July 30, 2021

Version 3

Safety Recall: 2018-19 Accord Fuel Pump MotorSupersedes 20-043, dated June 19, 2020, to revise the information highlighted in **yellow**.**AFFECTED VEHICLES**

Under REPAIR PROCEDURE, steps 6.2, 7, 9.1, 9.2 and 9.3 were revised.

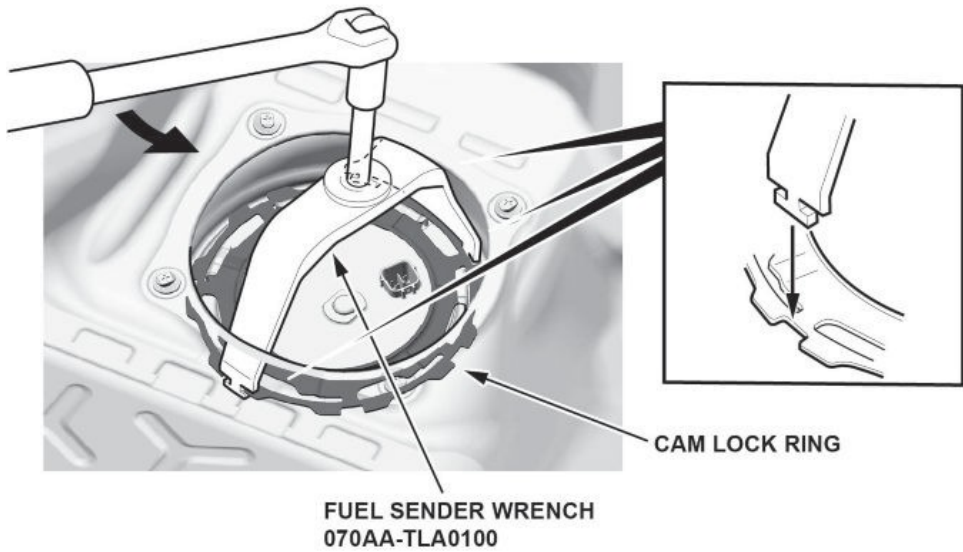
6.2. Turn the fuel tank unit cam lock ring counterclockwise.

NOTE: After unlocking the fuel tank unit cam lock ring, clean the top of the fuel pump flange and adjacent areas to make sure it's free of dirt, dust, and debris.

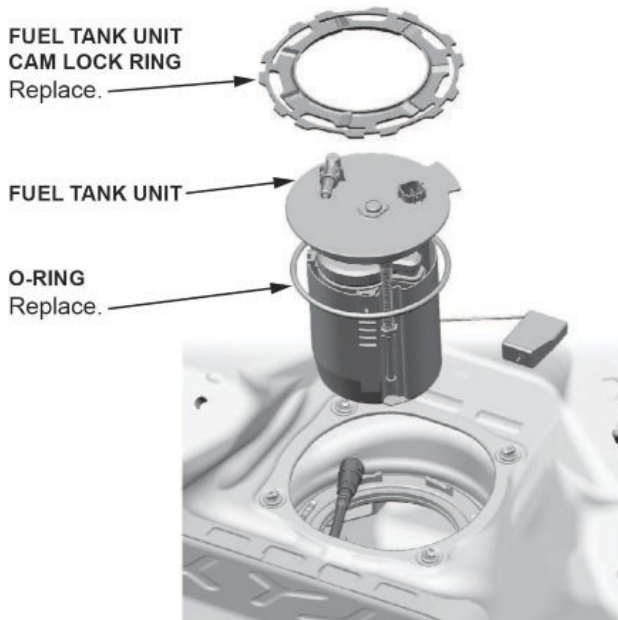
7. Remove the fuel tank unit.

- After removing the fuel pump unit, clean the fuel tank around the fuel pump opening.
- After removing the fuel pump O-ring, clean the fuel tank around the O-ring opening and make sure it's free of dirt, dust, and debris.

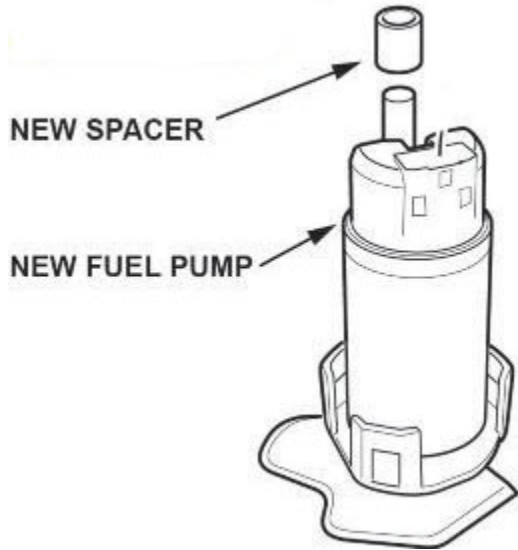
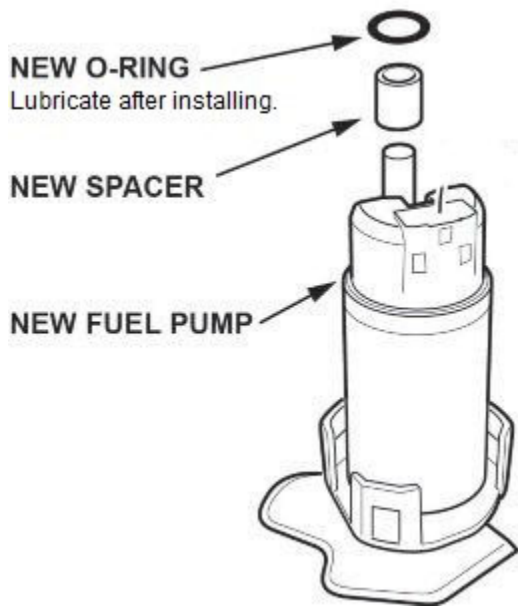
9.1. Install the new spacer on the new fuel pump motor.

9.2. Install the new O-ring, then lubricate the outside edge of it, using only clean engine oil.

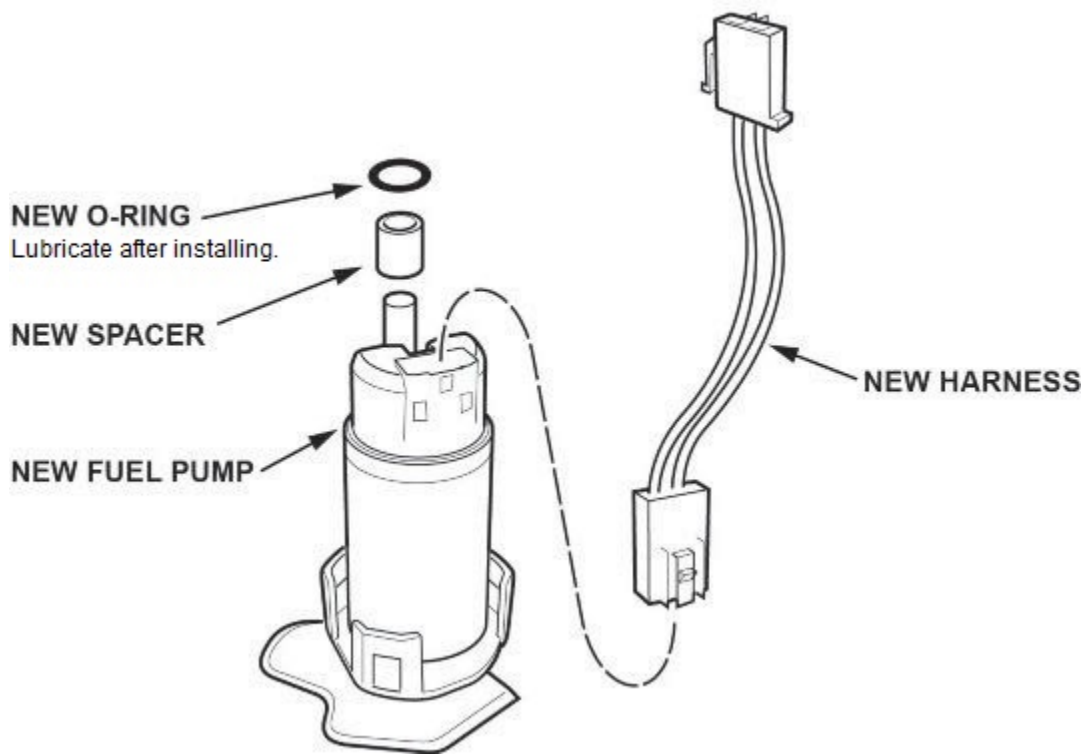
9.3. Install the new harness and make sure the connection is secure and the connectors are firmly locked into place.
